TALLAWONG STATION **PRECINCT SOUTH**

ADDENDUM URBAN DESIGN REPORT

Rev. E_10.12.2020

SITE 2 BUILDING HEIGHTS

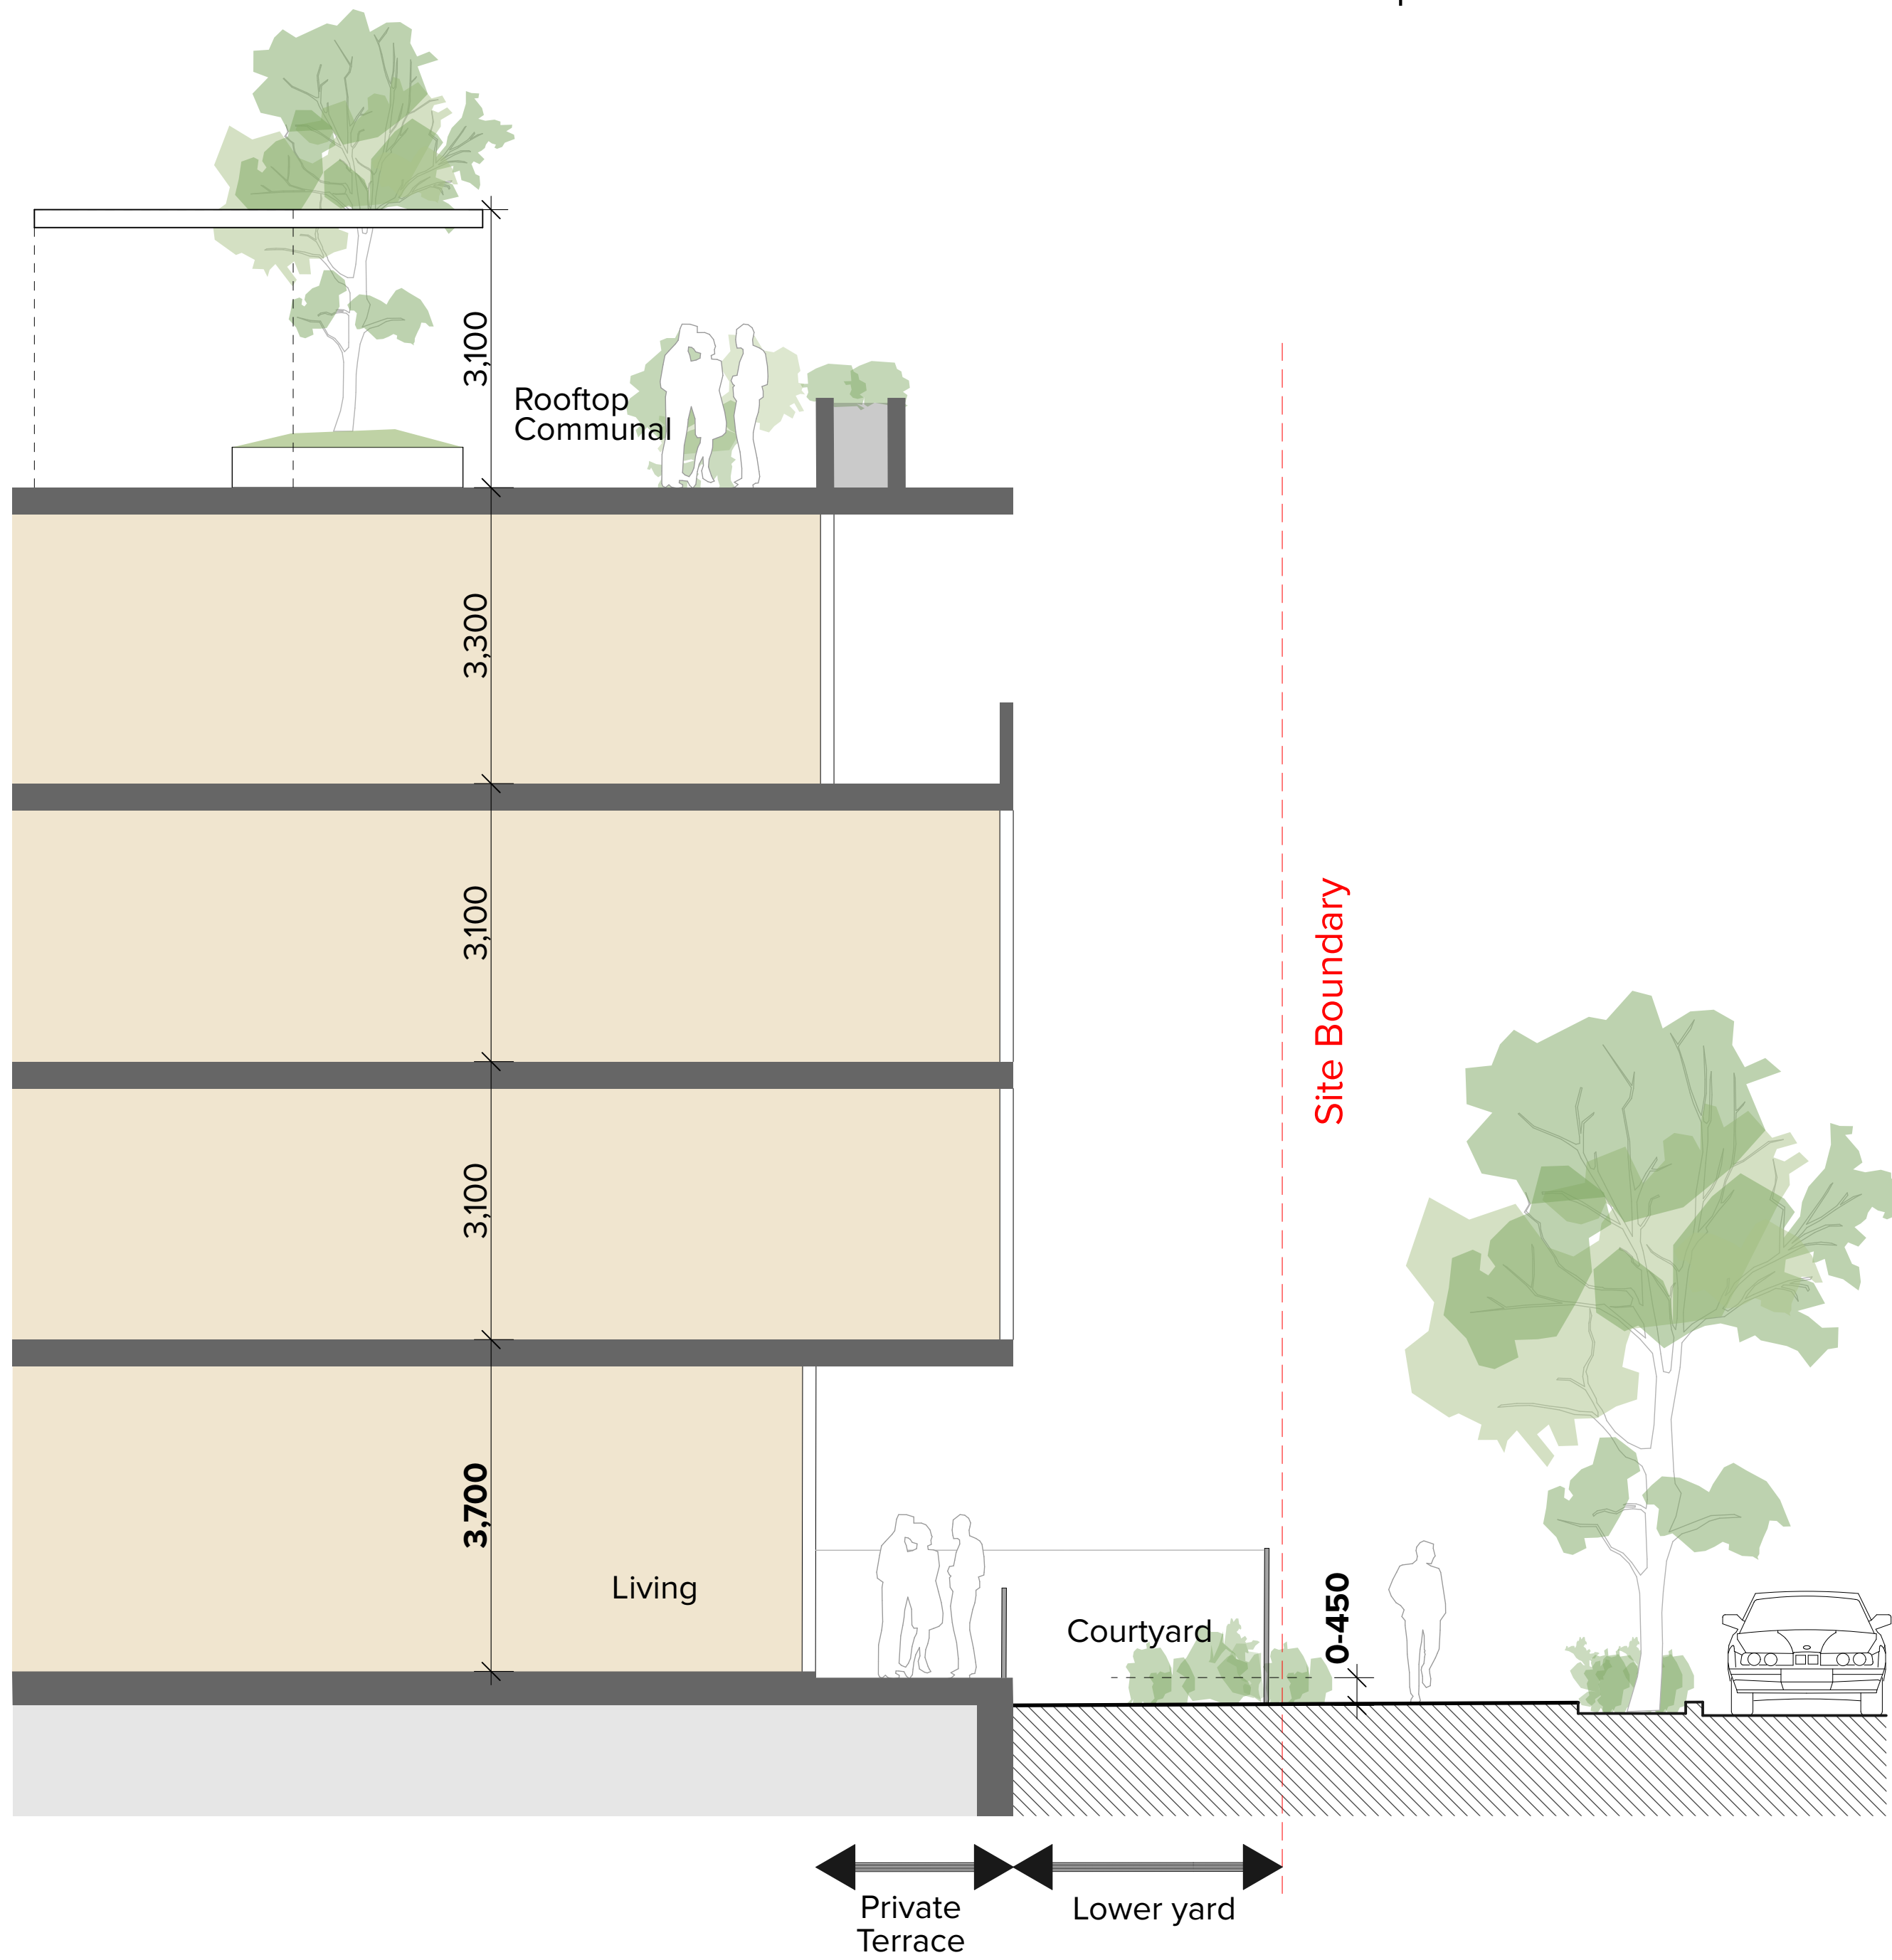
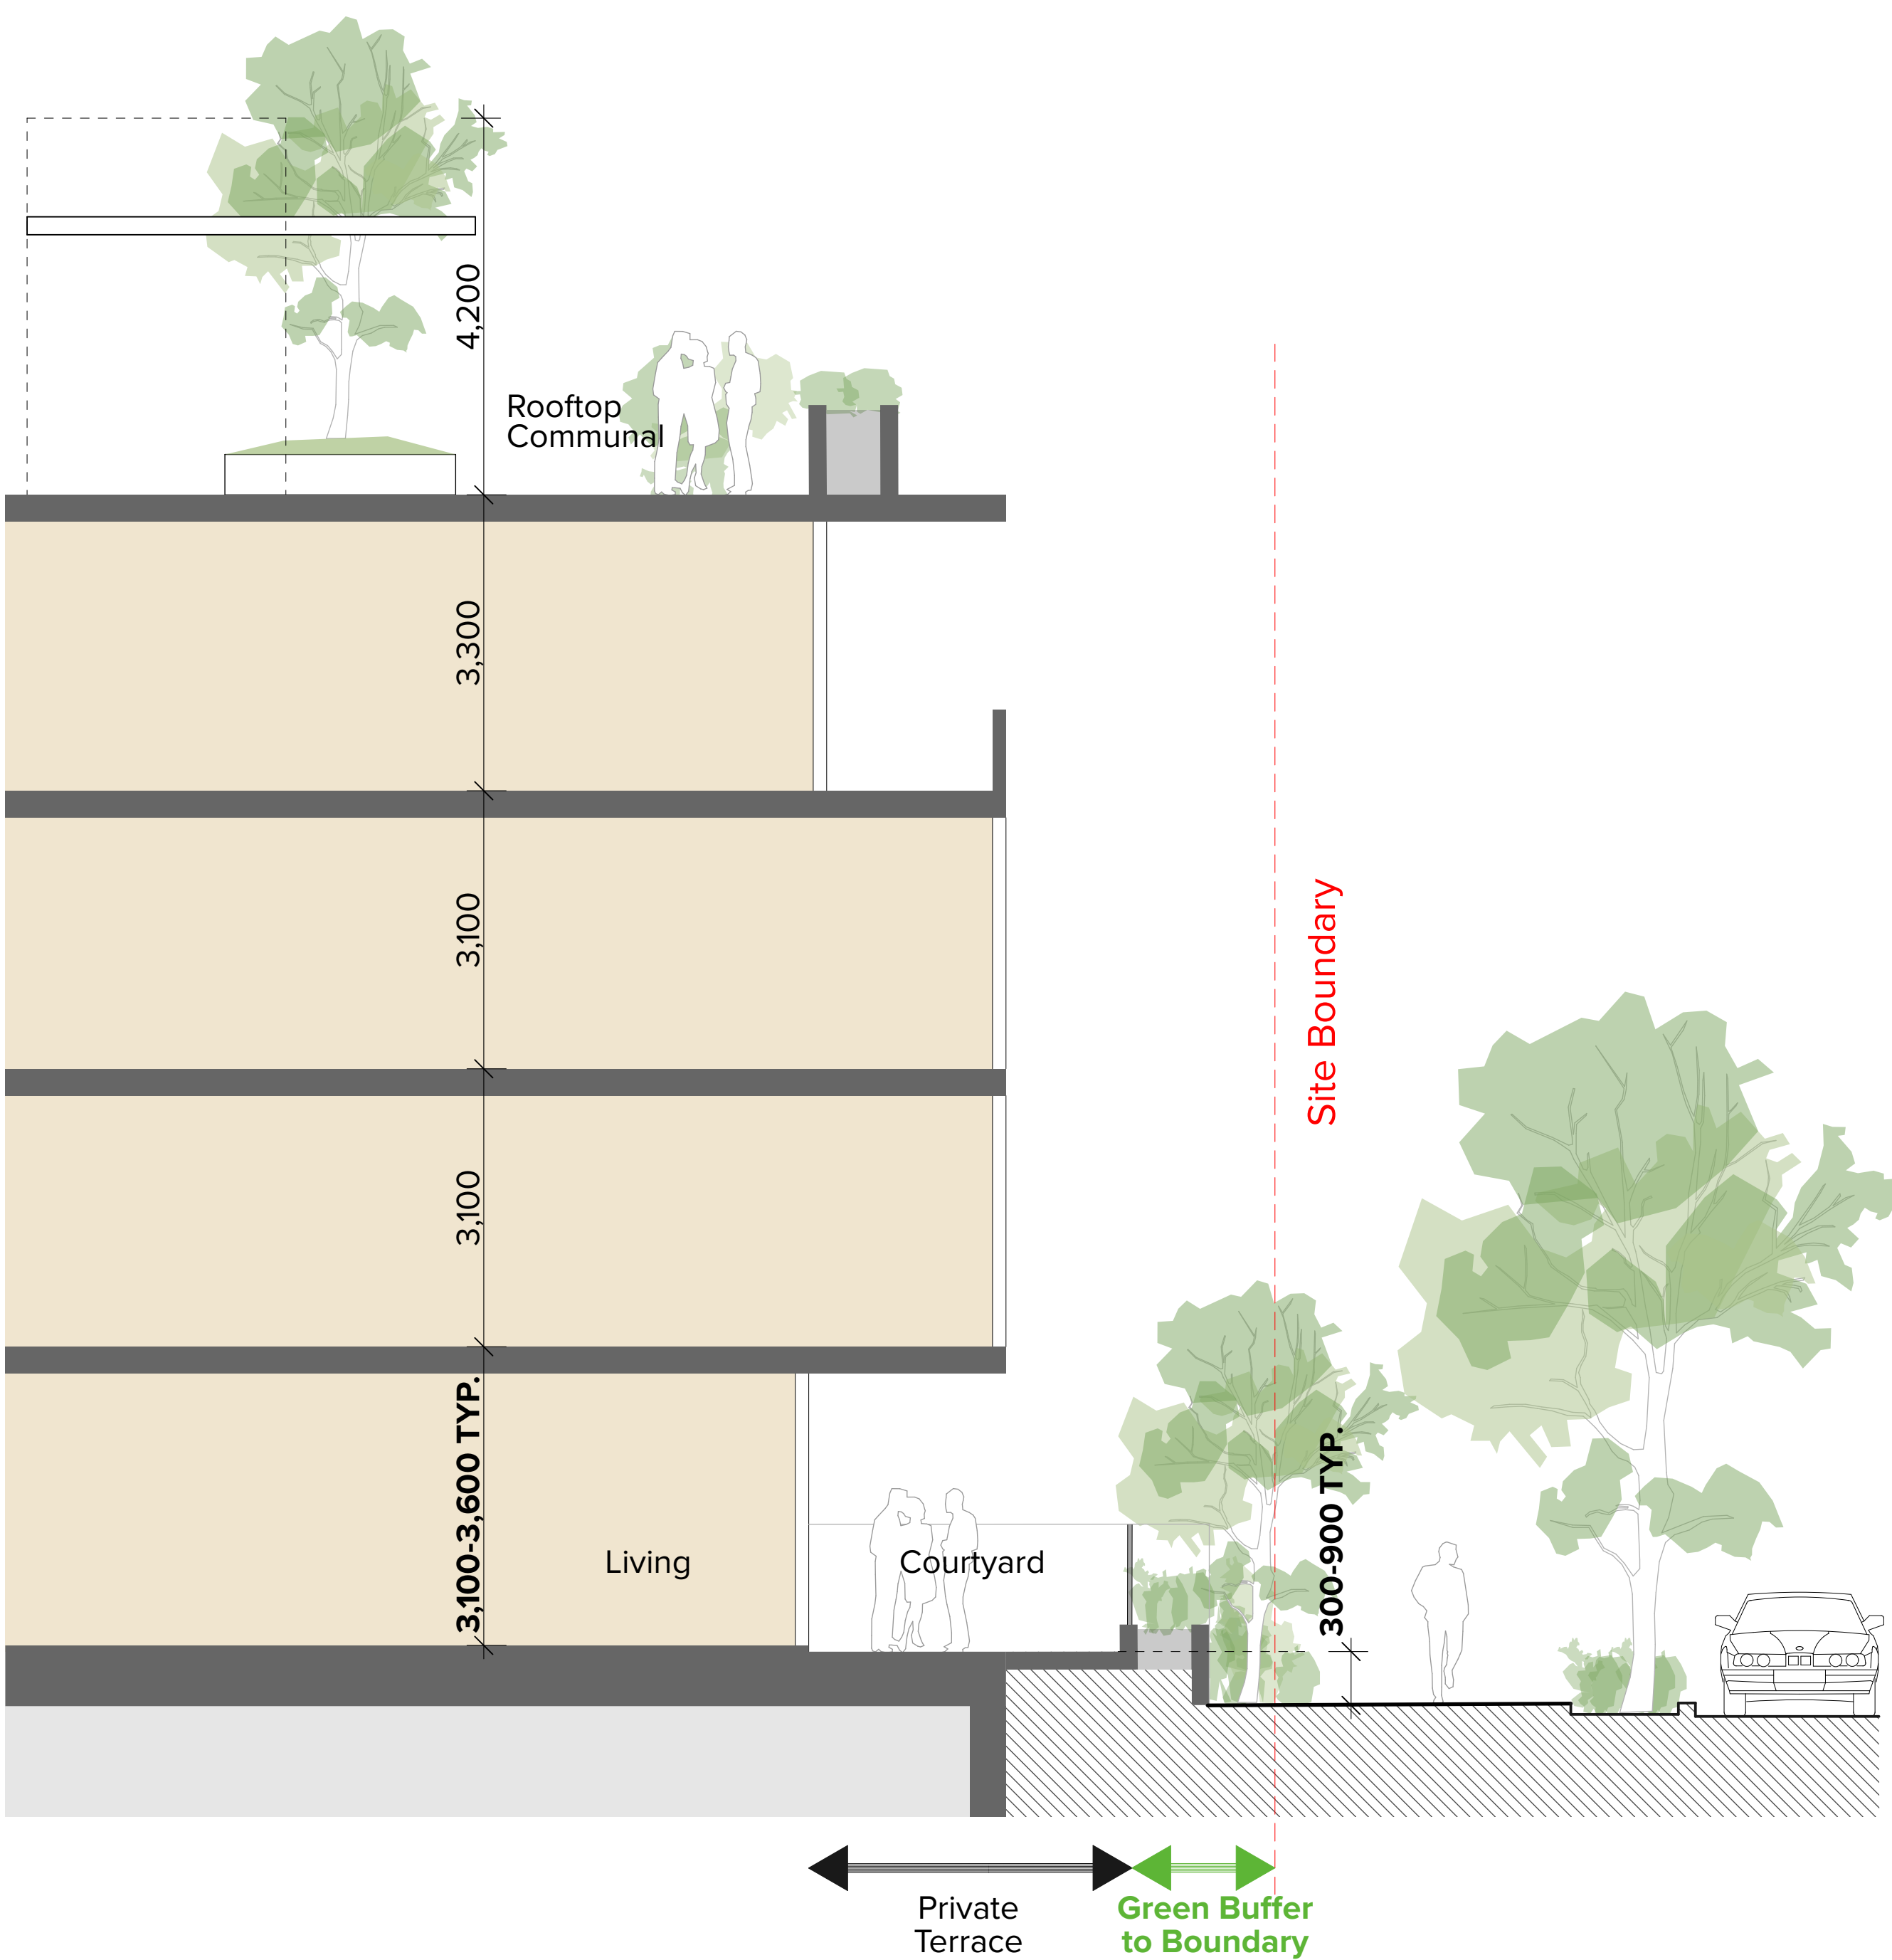
The Approved SSDA allowed for a 3.7m high ground level (floor to floor) to provide an "adaptable residential" level. Given the large provision of non-residential uses (9,000sqm GFA) within Site 1 "Town Centre" it is not considered necessary to provide for future adaptive re-use within the Site 2 "Residential neighbourhood".

Notwithstanding the above, the natural fall of the land allows for a range of heights within the ground plane from 3.1m to 3.6m (floor to floor).

The ground level apartments are proposed to have their floor level set at 300-900mm above the footpath level (typically). The courtyard is proposed to be elevated to provide a consolidated open space, as opposed to the split scenario proposed in the SSDA. This allows for amenity and privacy for residents while maintaining passive surveillance and an active public domain.

The overall height of the building is slightly lower than the SSDA, though the height of the lift overrun has been increased to reflect manufacturers requirements.
